Product Change Notification (PCN)

DSUB Cable

Change Notification: **PCN-US-20180701 AK553F-2**

Products Affected: **AK553F-2**

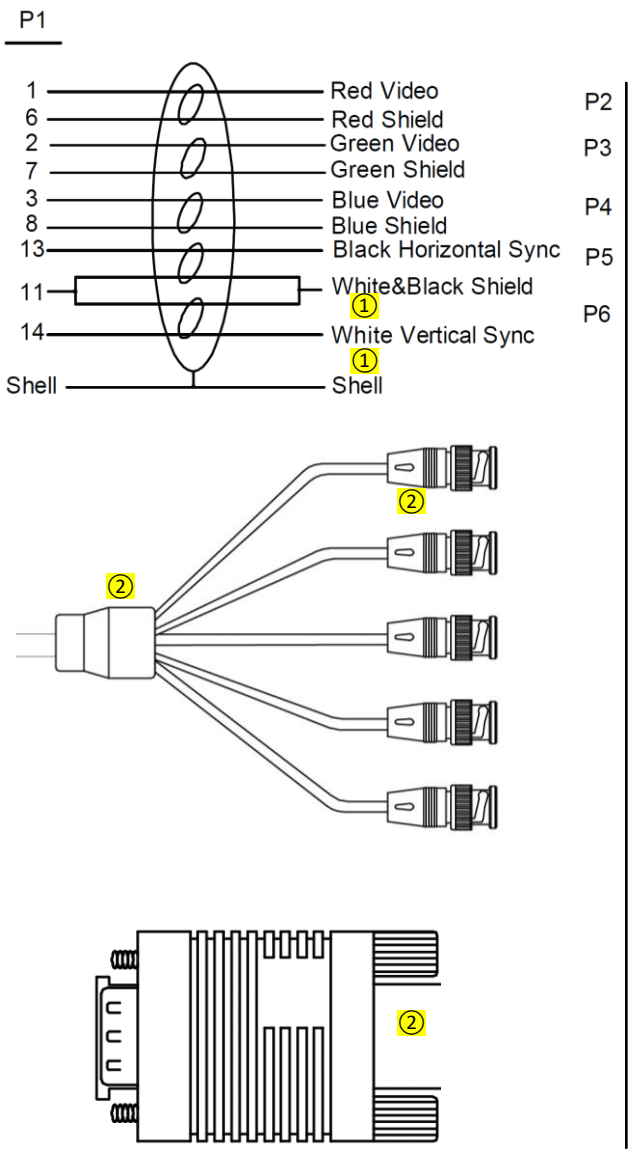
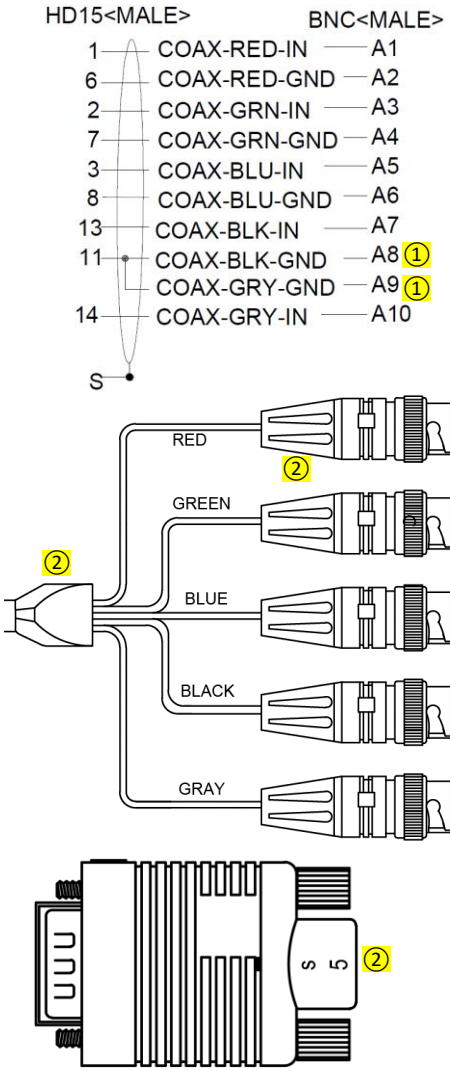
①: Change of white wire to gray wire.

②: Change of over-molding designs.

Drawing-No.
ASS 8320 CA

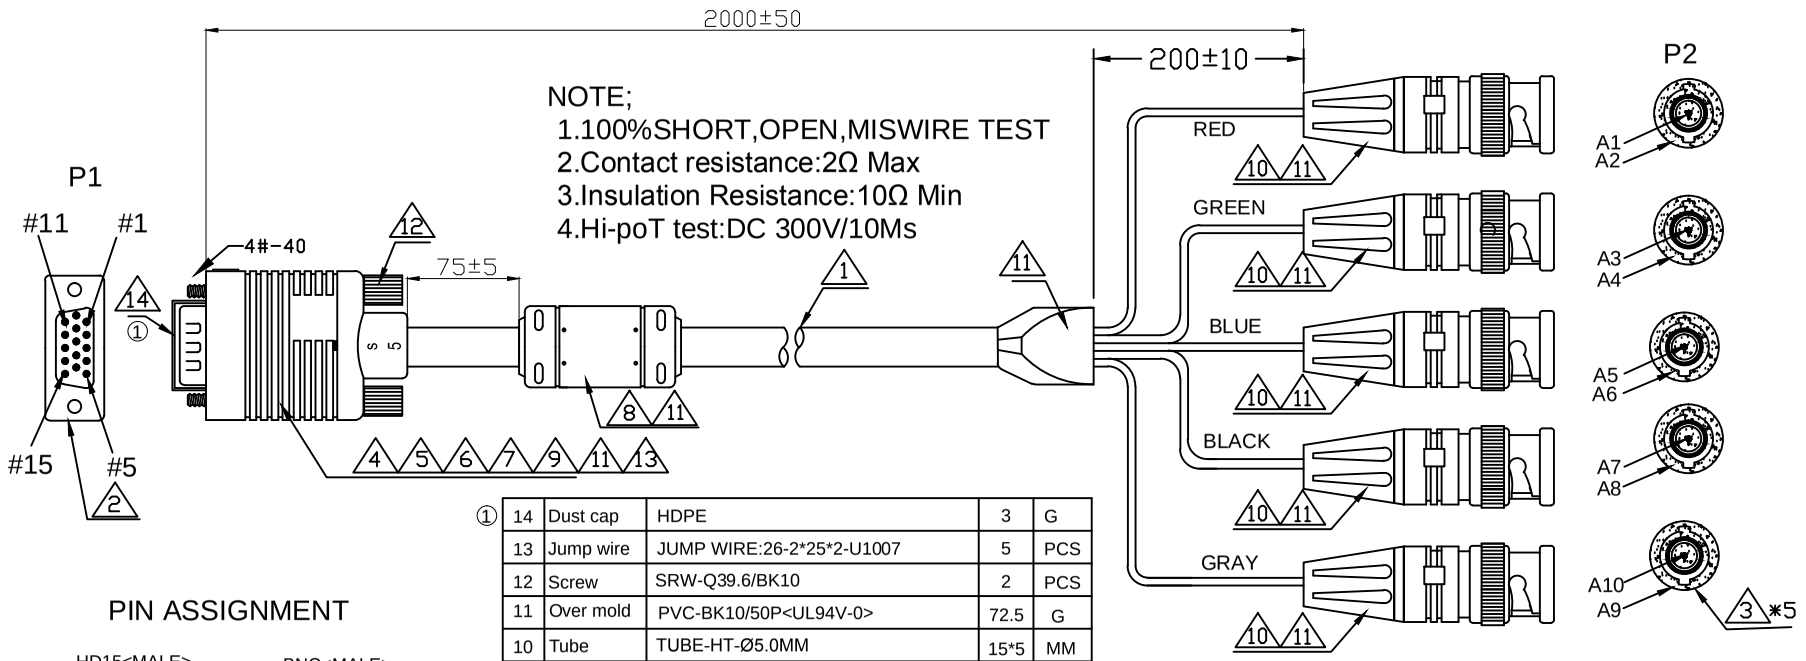
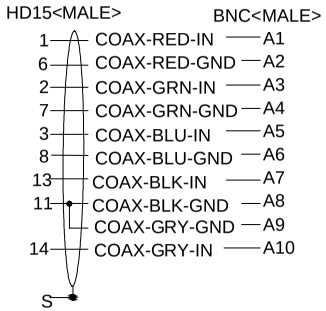
1. **Change of tooling**
2. **Change of specifications**
   a. **Change of wire color (see page 2)**
   b. **Change of over-molding design (see page 2)**
   c. **Drawing ASS_8320_CA (see page 3) replaces all previous drawings**

Id.	Modification	Date	Name
①	Add dust cap	16.07.2018	Xaiver
⓪	Drawn	06.07.2018	Xaiver
